**BCC DS**  
**RECEIVED**  
08-MAY-2026  
**APPLICATION REF**  
A007020190

DA Set - 21.02.2024.

DA Set - 15.02.2026.

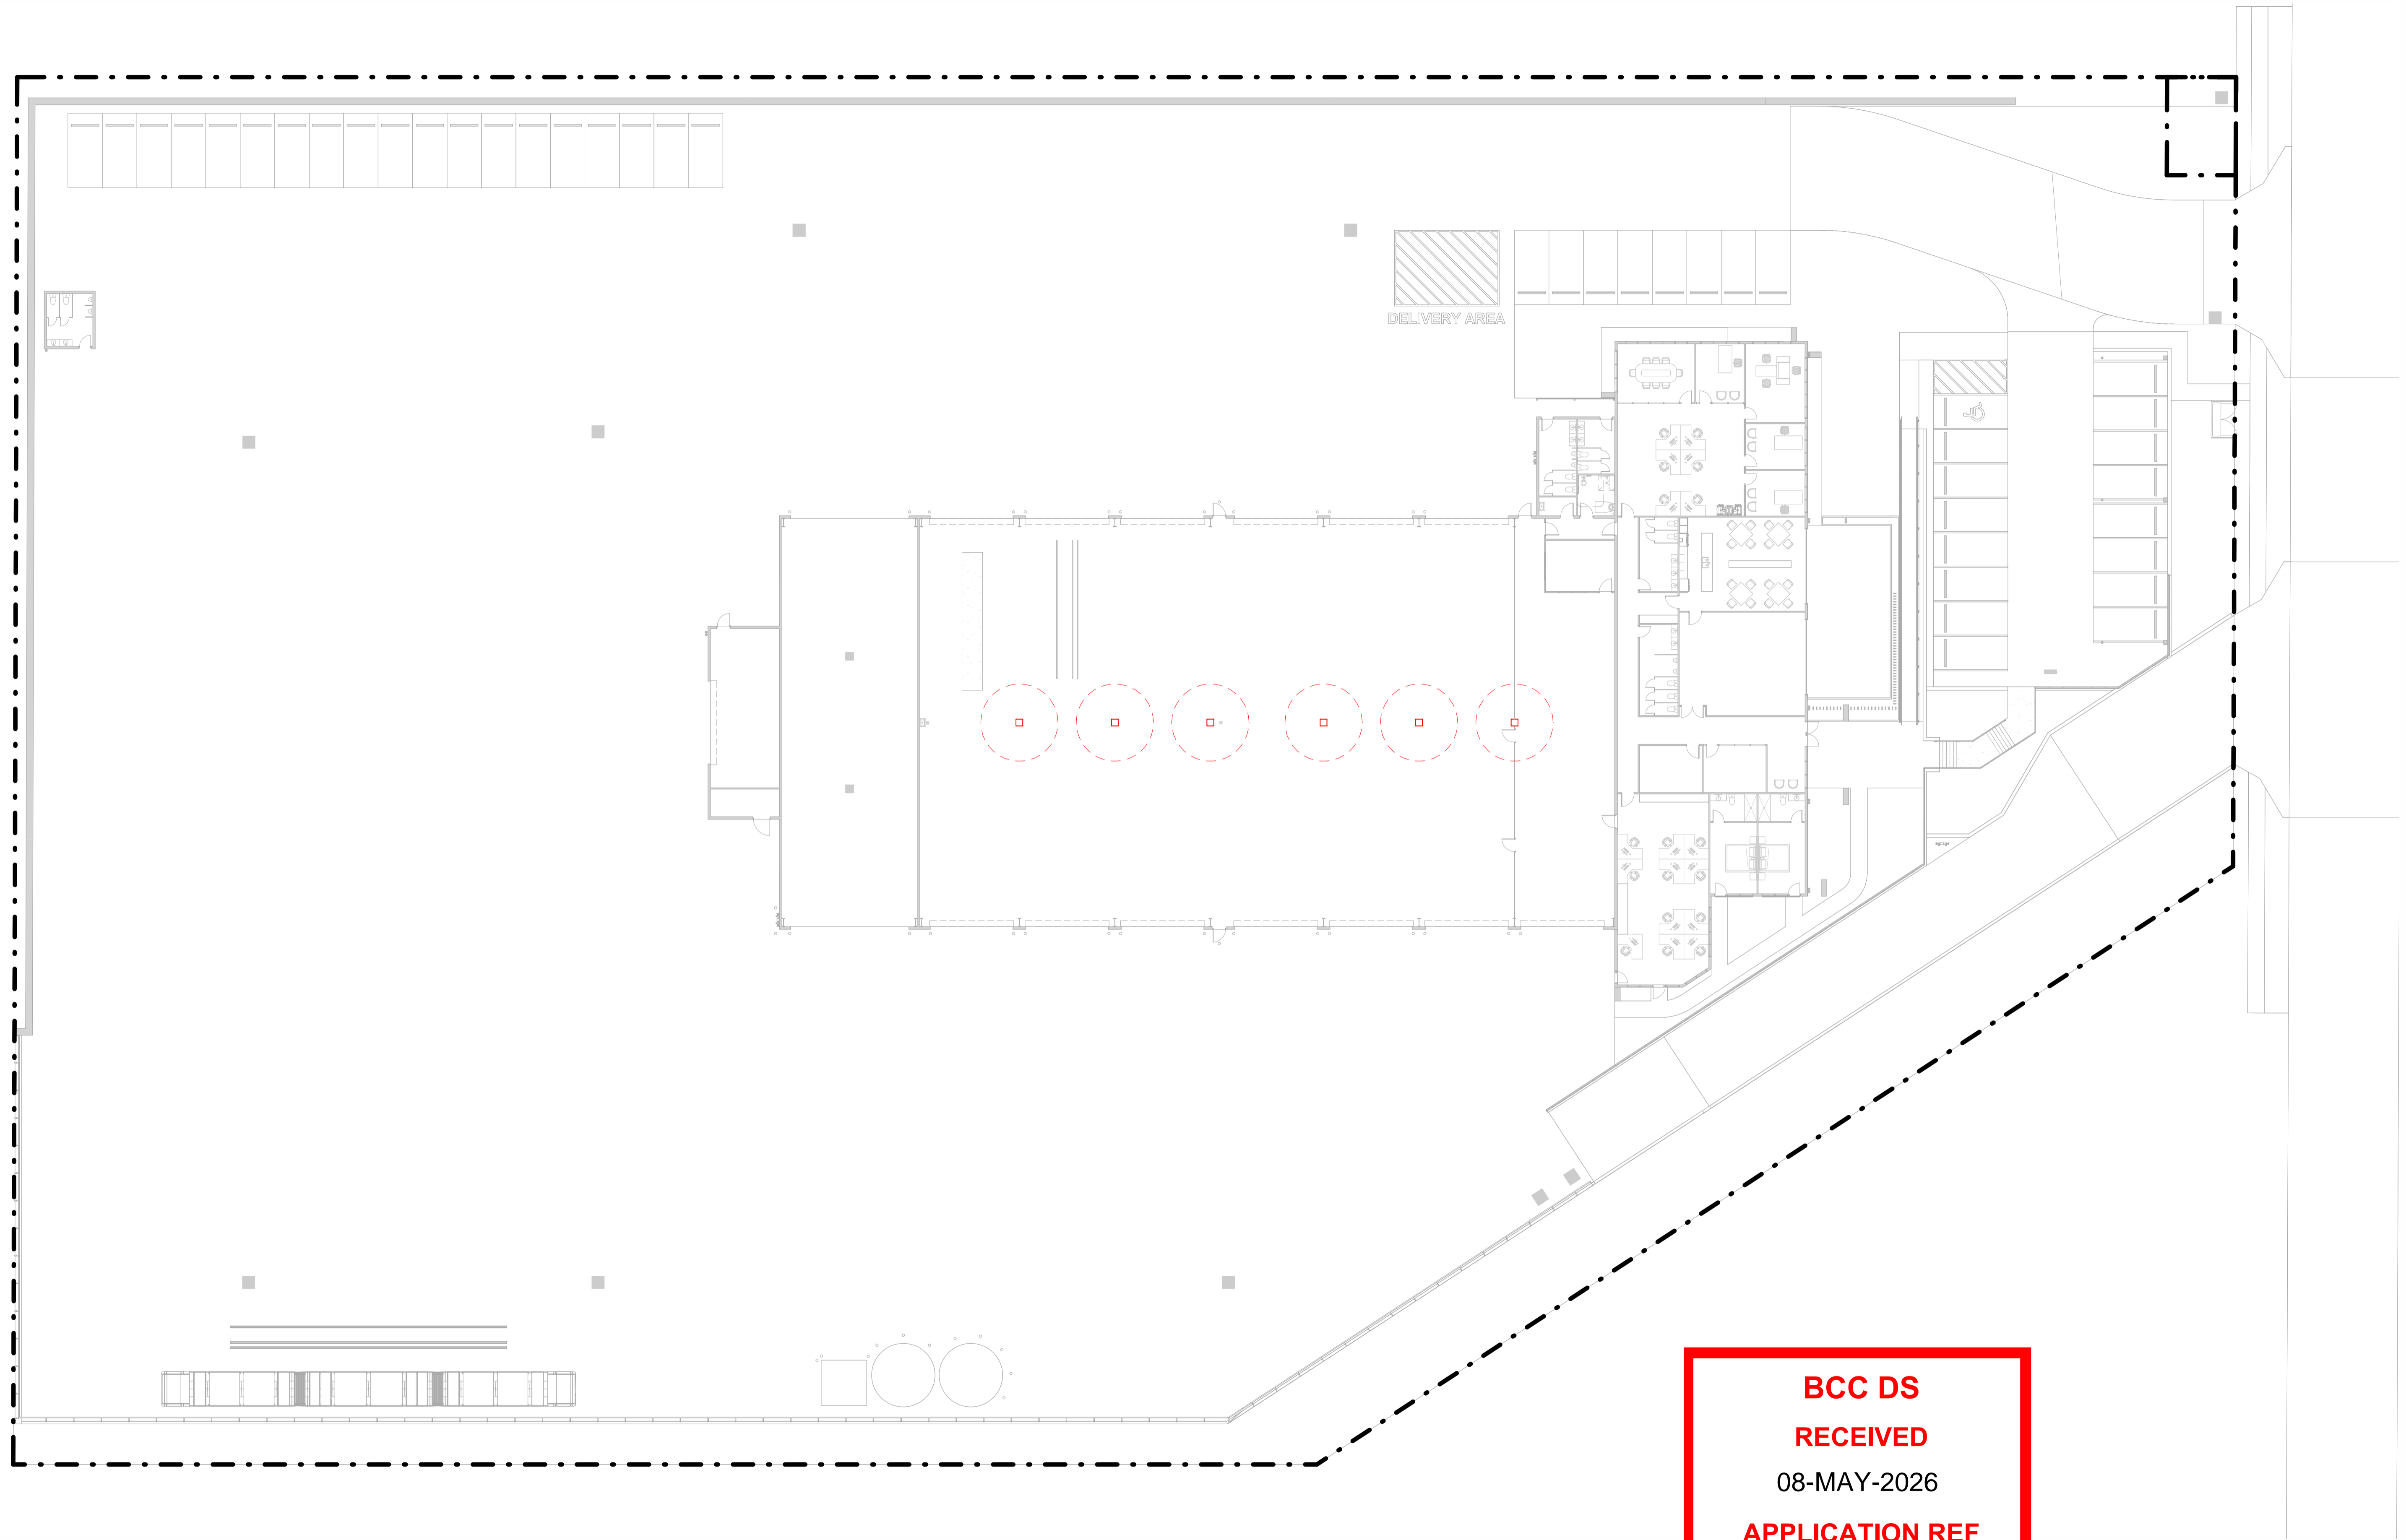
10. Central structural columns have been introduced.

Rev\_10

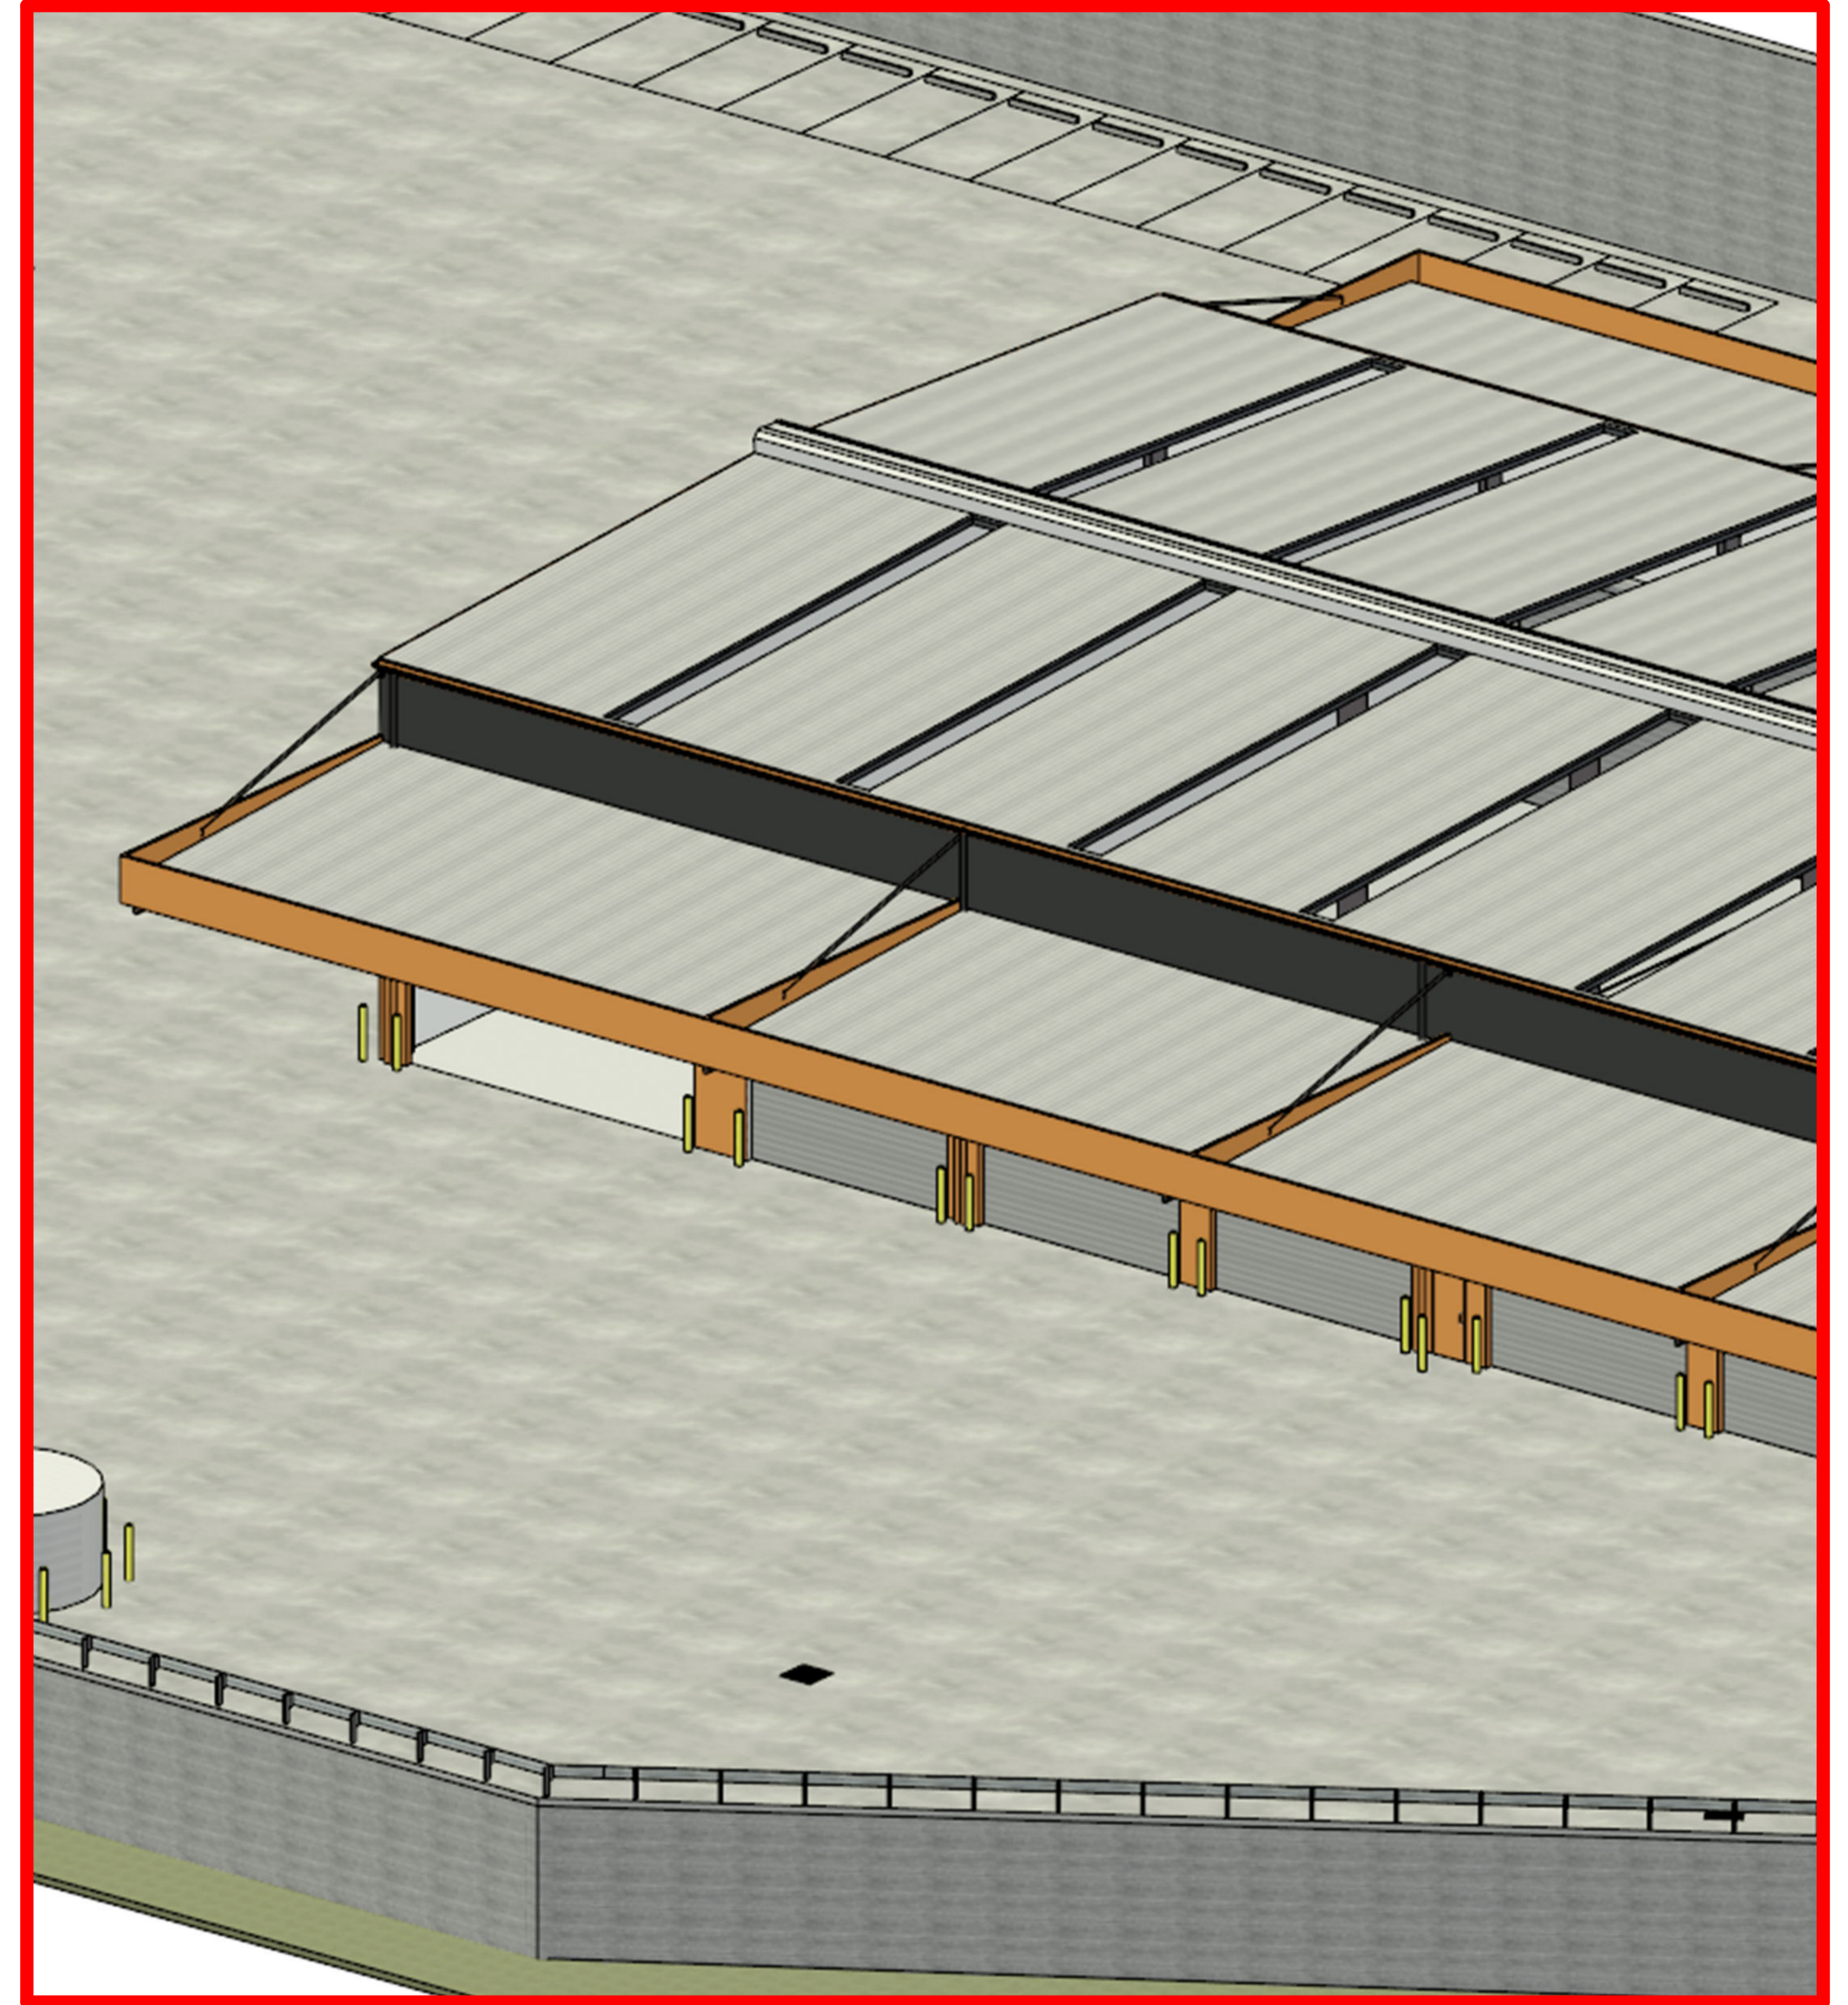
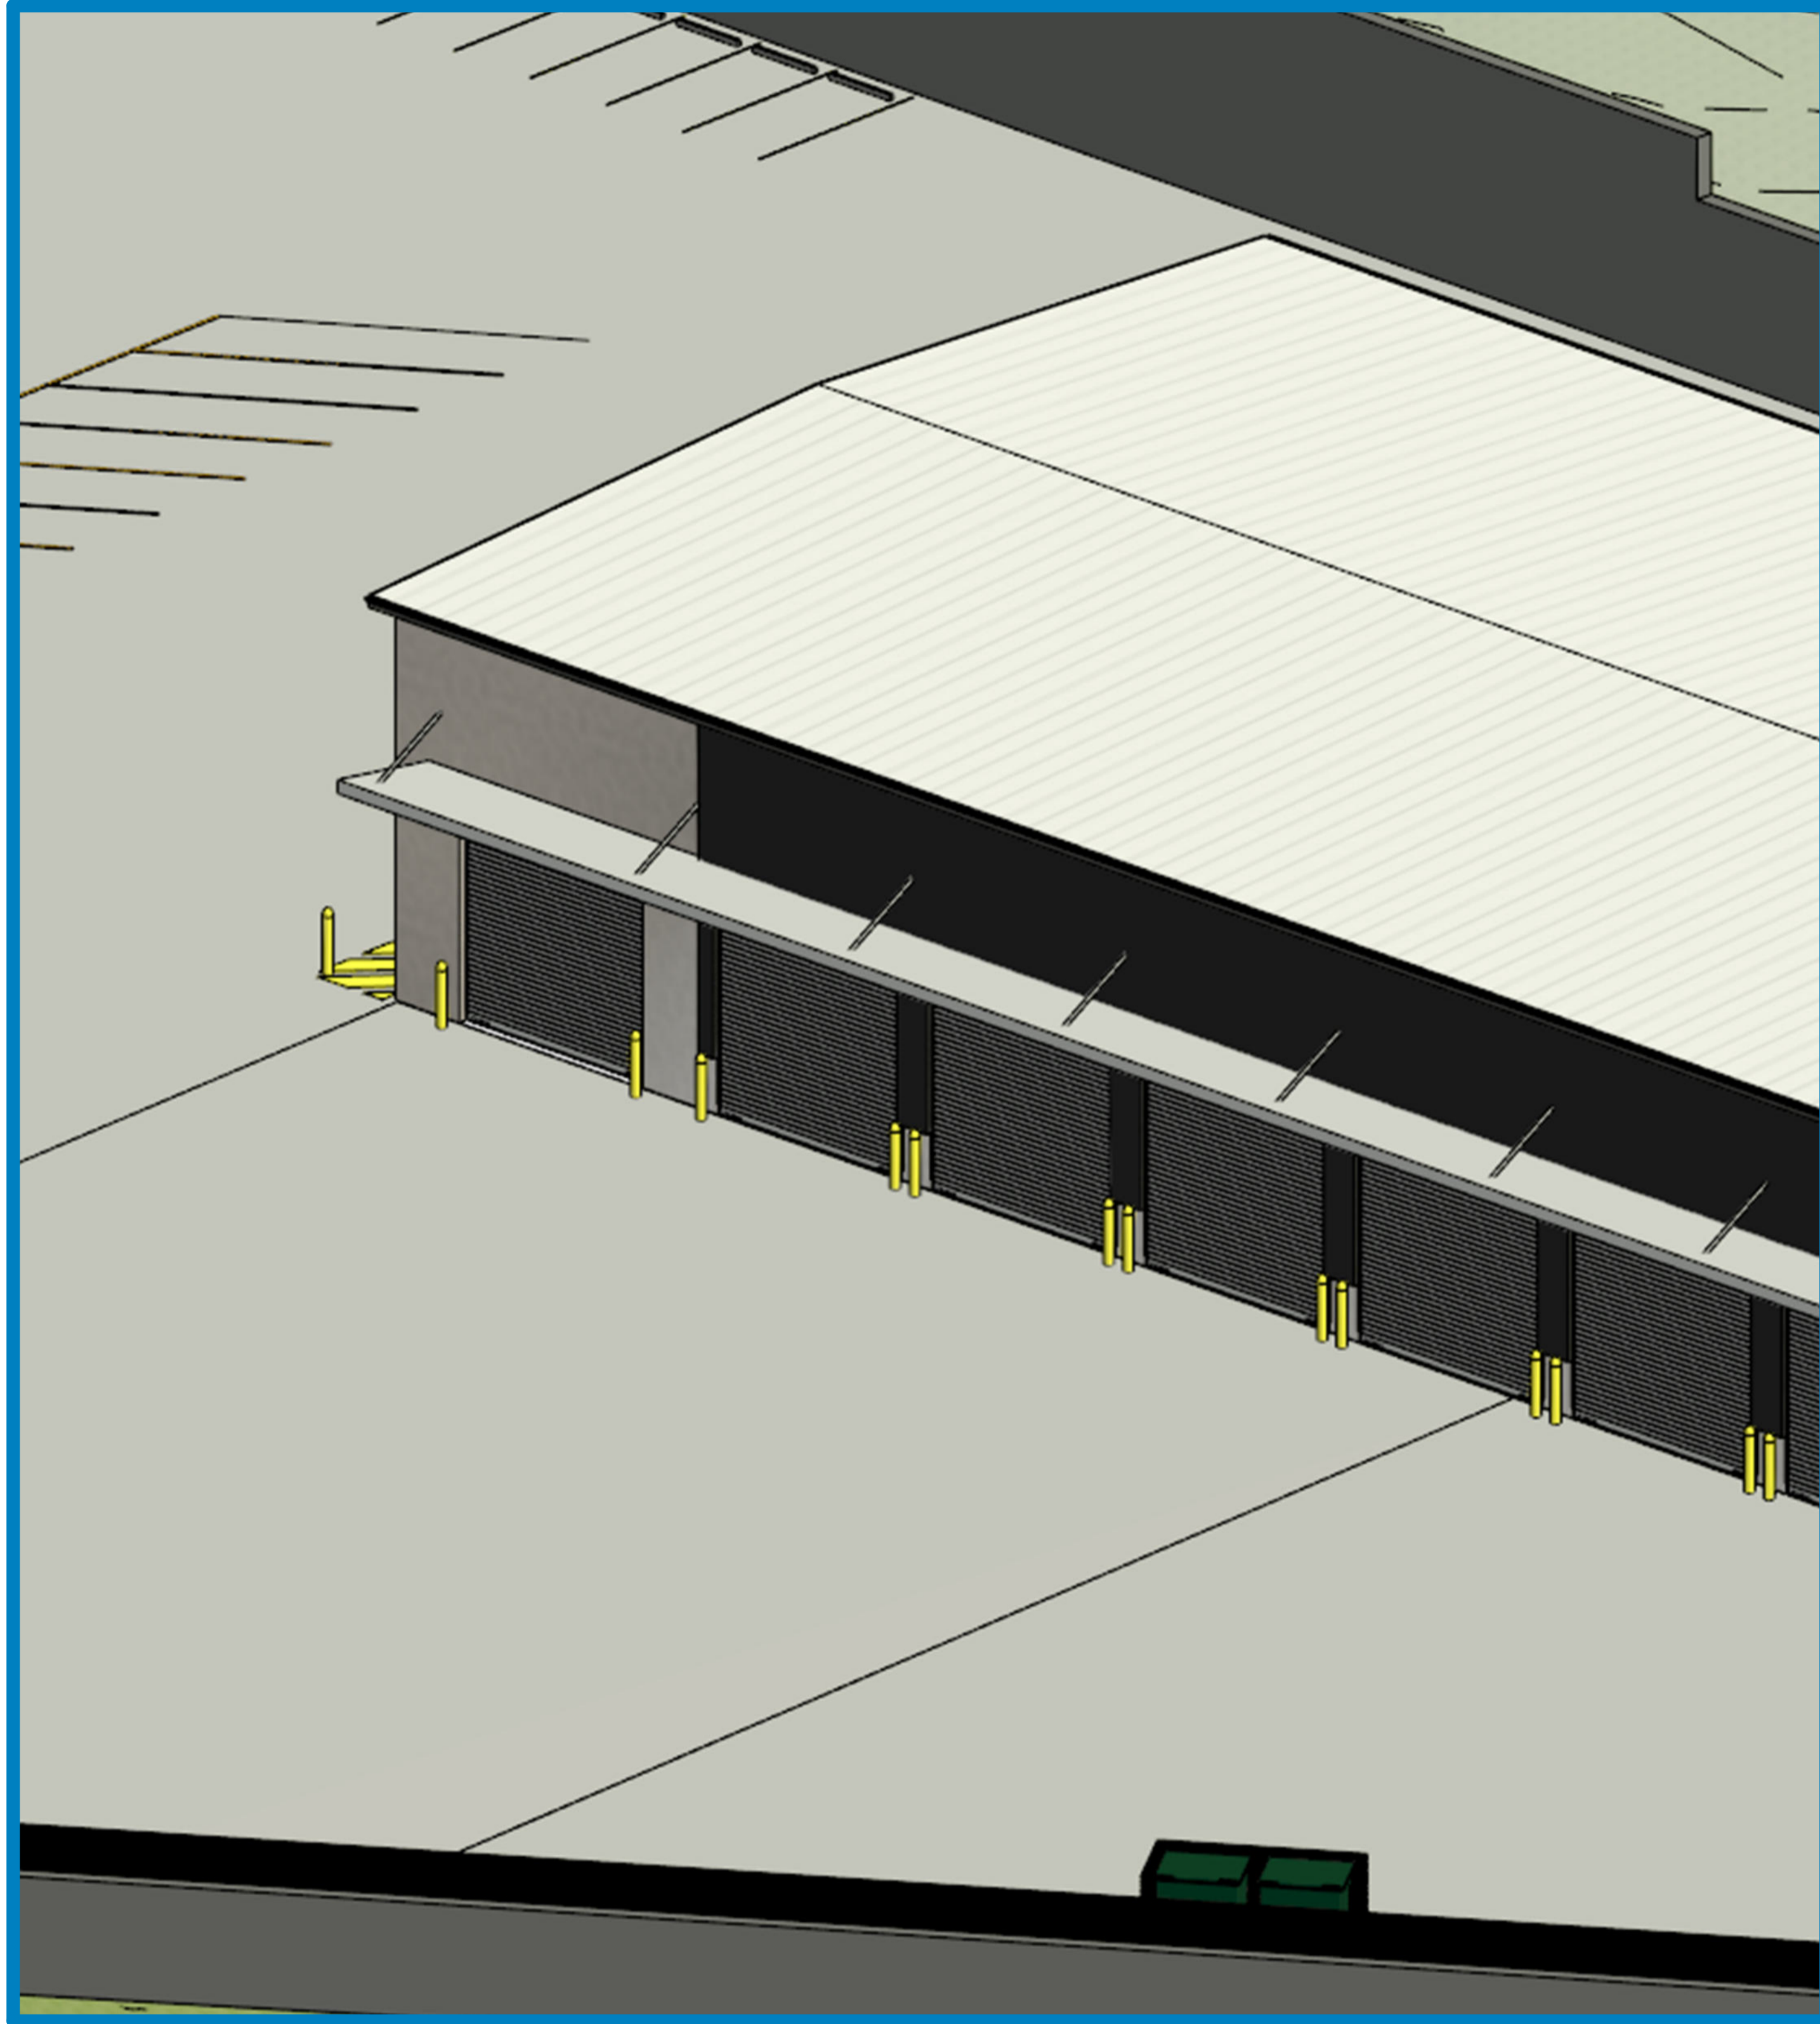
12. The awning above the warehouse roller doors has been extended to a depth of 10m.
